RE: Review Comments
Tierra Linda Apartments
Albuquerque, NM
Plan Check No. PR-2021-005630
Project No. 24-2031-01

Below, please find our responses to your comments dated 12/11/24:

DFT Resubmittal

SHEET TITLE				
LANDSCAPE PLAN				
DRAWING SHEET				
LP-101

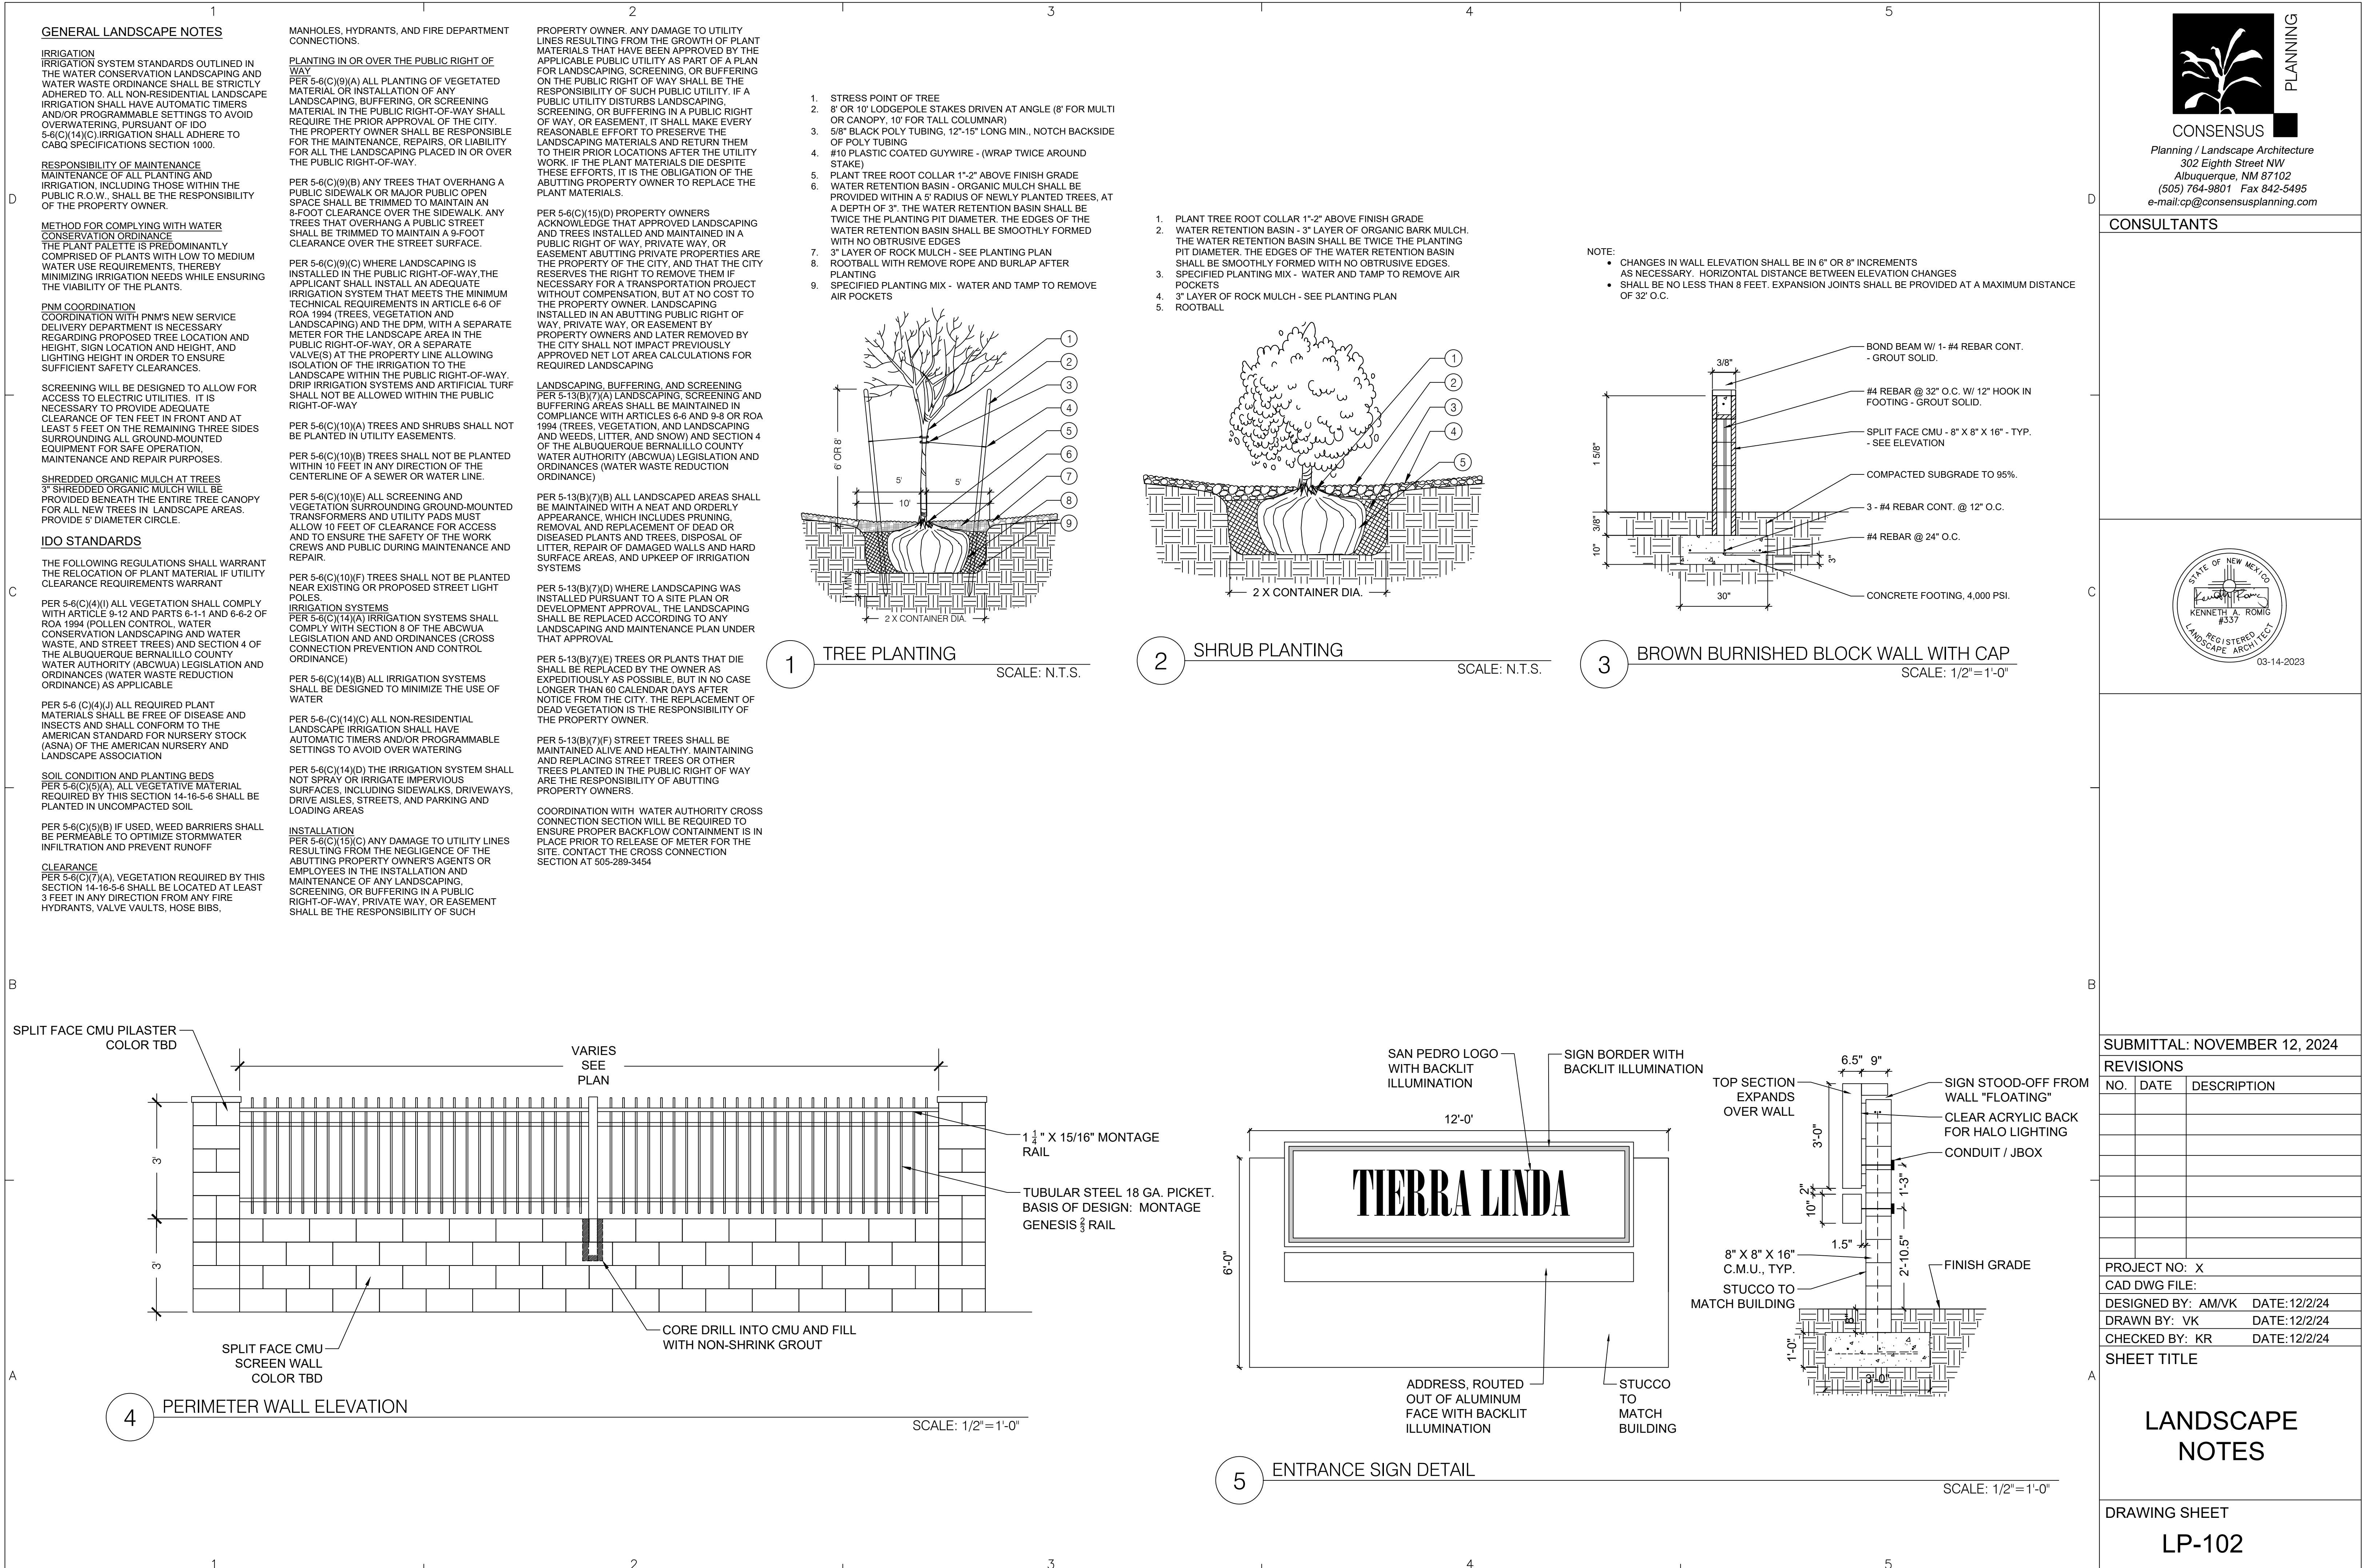
11. Provide the required organic mulch area for this project on the Landscape Plan
 - ***The required organic mulch calculation is provided in 'Gravel Mulch Coverage' on Sheet LP-101.***

15. 4-3(B)(8)(c)2: 25% of the net lot area shall contain landscaping; playgrounds, sport courts, swimming pools, or similar features may count up to ten percent of net lot landscaping. Tree canopies and ground level plants shall cover a minimum of 75 percent of the total landscaped area, and the maximum a tree canopy shall count toward this requirement is 600 sf.

16. 4-3(B)(8)(c)3: Cool season grasses are restricted to 20 percent of the landscape area. Warm season grasses may cover up to an additional 70 percent of the landscape area.

17. 4-3(B)(8)(d): At least 50 percent of the trees required by Subsection (b) or (c) above shall be deciduous canopy-style shade trees or coniferous trees capable of attaining a mature canopy diameter of at least 25 feet.

- *All vegetation is from Albuquerque and Water Authority approved plant list.*
23. Per 5-6(C)(5)(d), a minimum of 2 inches of organic mulch is required in all planting areas, with 3-4 inches recommended.

- ***44% of the lot is landscaped. We have one playground in the center of the lot, which comprises 2% of the net lot landscaping. We have 75% vegetation coverage with the appropriate amount coming from trees, see 'Coverage' calculations on Sheet LP-101.***

- ***We only have cool season grasses in the central courtyard area. This area makes up 6% of the landscape area. See 'Cool Season Grasses' on LP-101. Warm season grasses are used in the water harvesting area, as well as on the bottom of the detention pond. This makes up 4% of the landscape area. See 'Warm Season' Native Grasses in the calculations on Sheet LP-101.***

- ***88% of the trees used reach a mature canopy of at least 25 feet, see Sheet LP-101.***
18. Clarify and confirm that all development landscaping/screening are within private property areas and not encroaching into the public right of way. Exception – Street/sidewalk landscape buffer can be within ROW

- *Organic mulch is specified at 3" deep. See Mulch Table on Sheet LP-101.*

PROJECT NO: X**CAD DWG FILE:****DESIGNED BY:** AM/VK **DATE:** 12/2/24**DRAWN BY:** VK **DATE:** 12/2/24**CHECKED BY:** KR **DATE:** 12/2/24**SHEET TITLE****LANDSCAPE NOTES****DRAWING SHEET****LP-102**

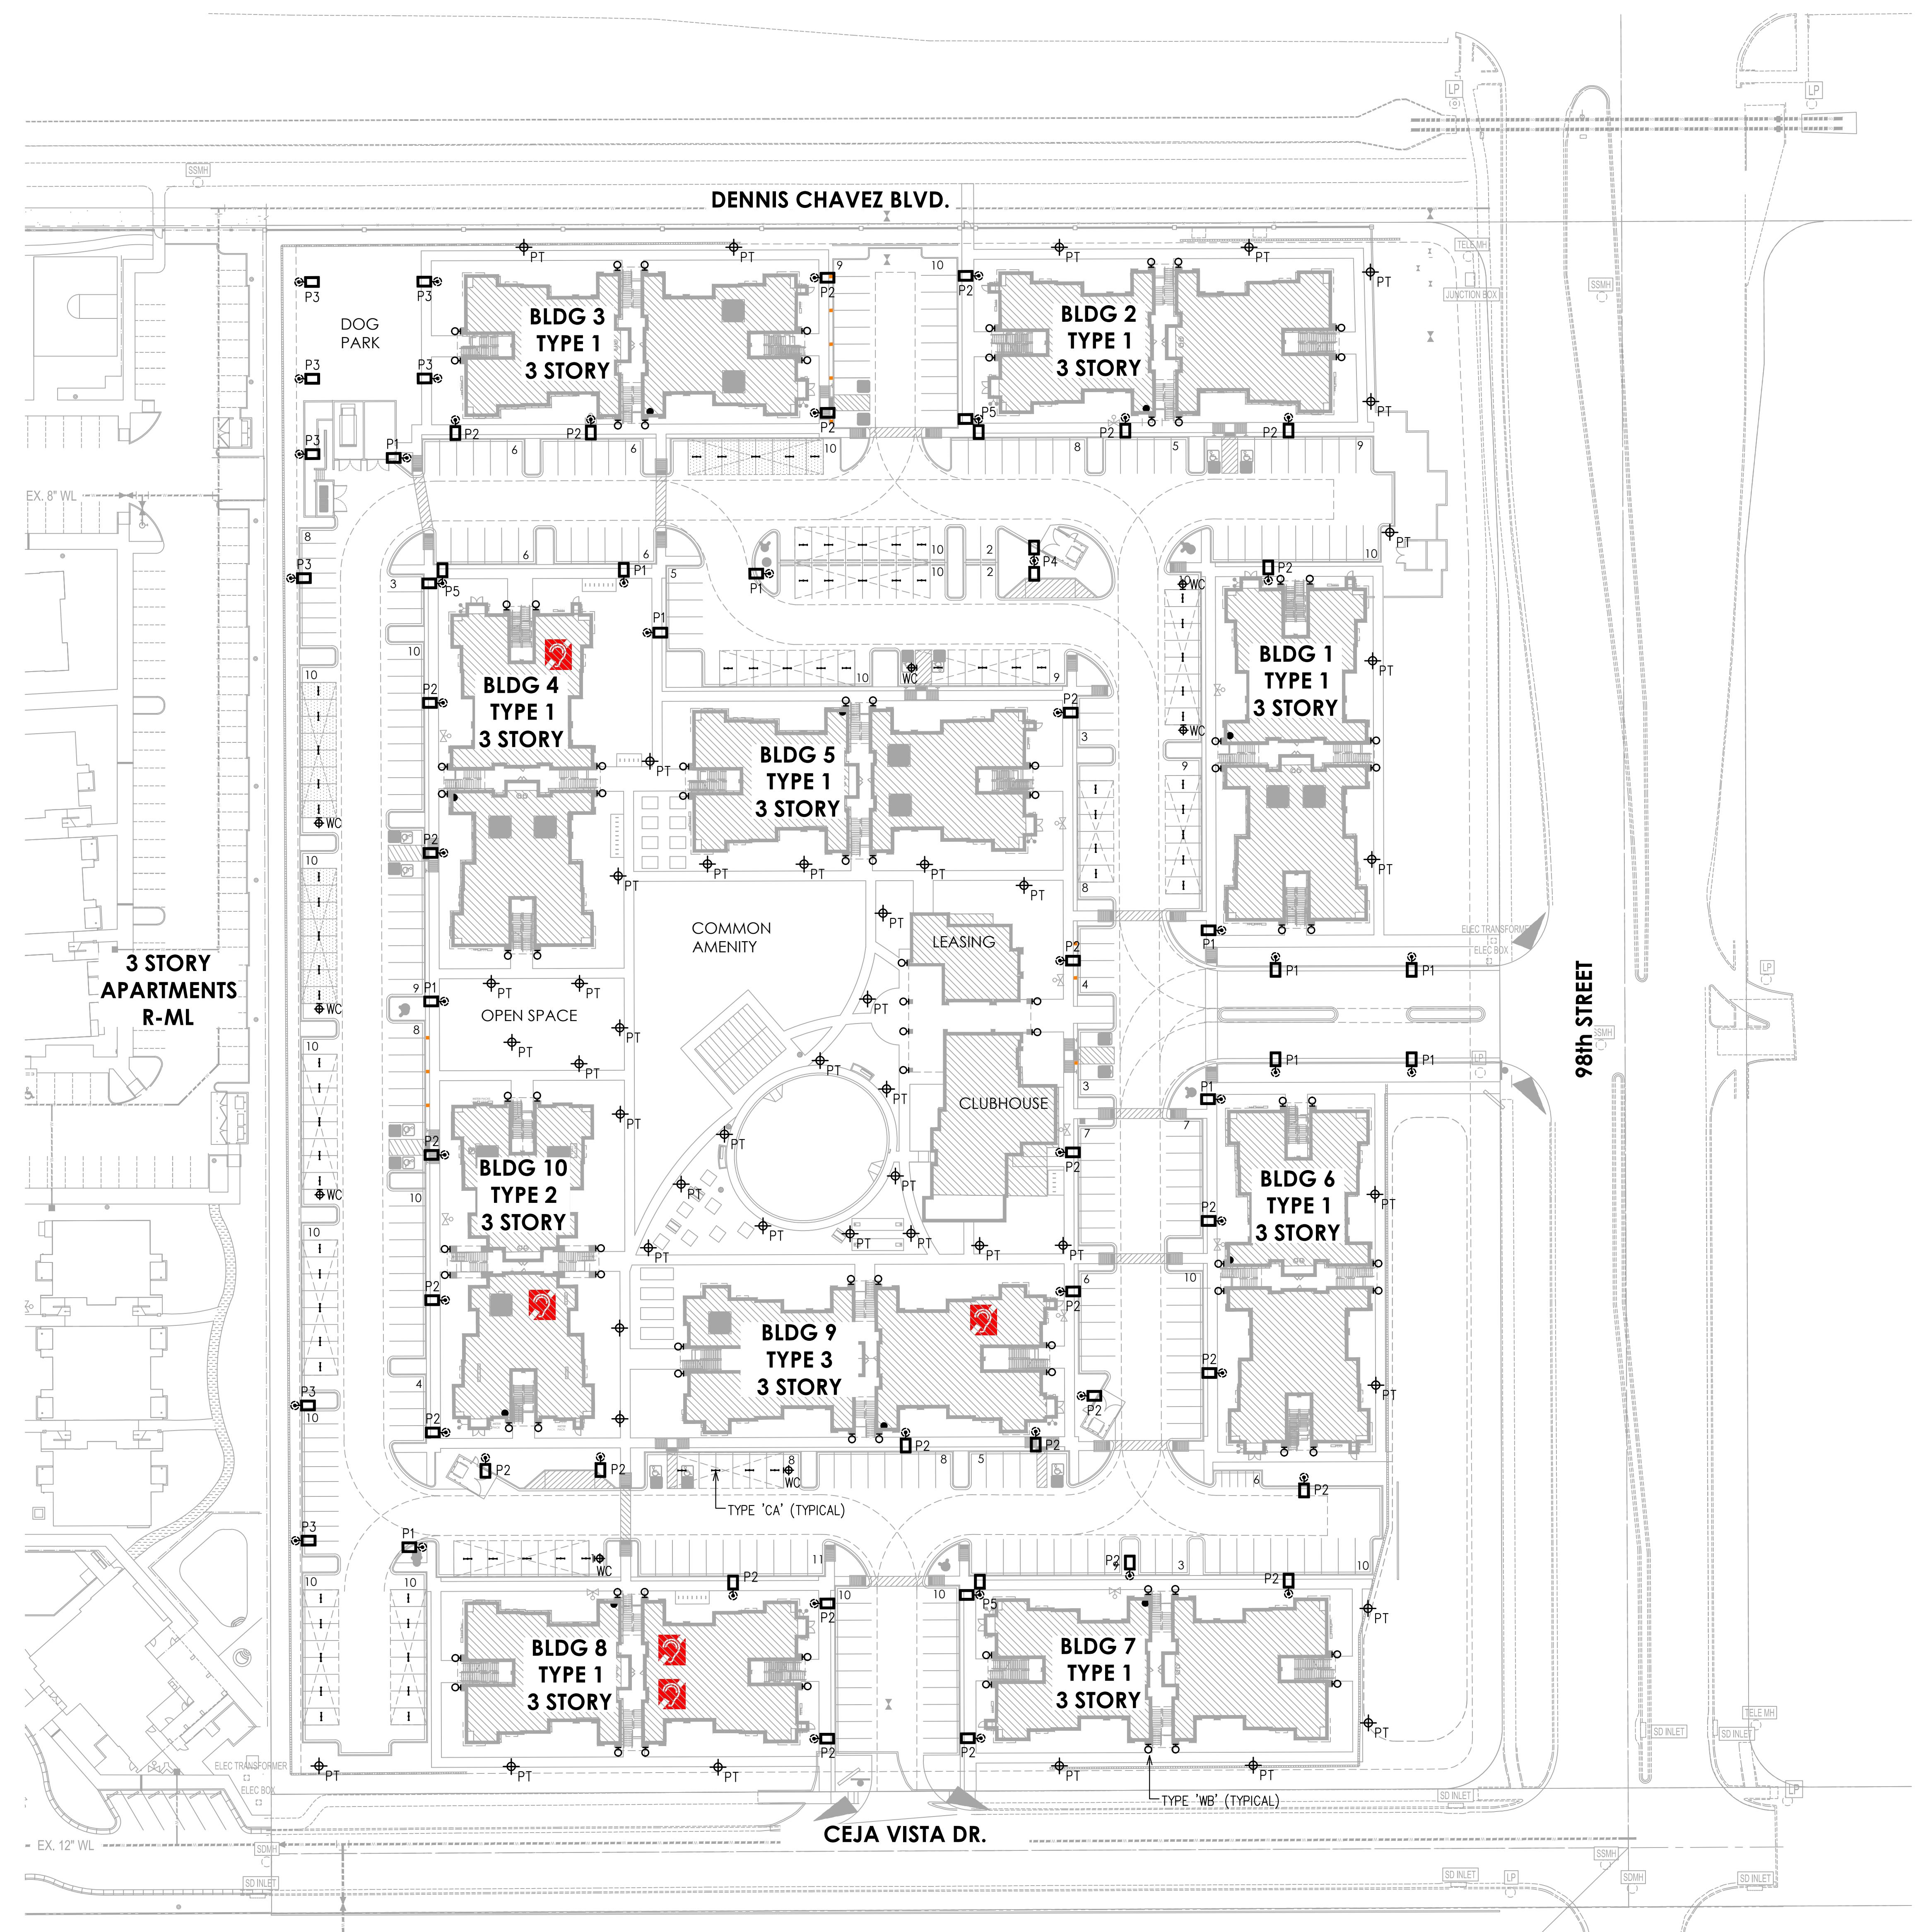
- **The trail is existing and complies with the following requirements.**
4. Outdoor ground-mounted mechanical equipment shall be located where it is not visible from streets, City parks or trails, Major Public Open Space, or major arroyos adjacent to the lot or from adjacent properties to the maximum extent practicable.

- **Compliant. See Clearance Note on Sheet LP102**
5. Outdoor loading, service, and refuse areas shall be integrated into the building design if possible, or shall be located where they are not visible from streets, City parks or trails, Major Public Open Space, or major arroyos adjacent to the lot or from adjacent properties to the maximum extent practicable.
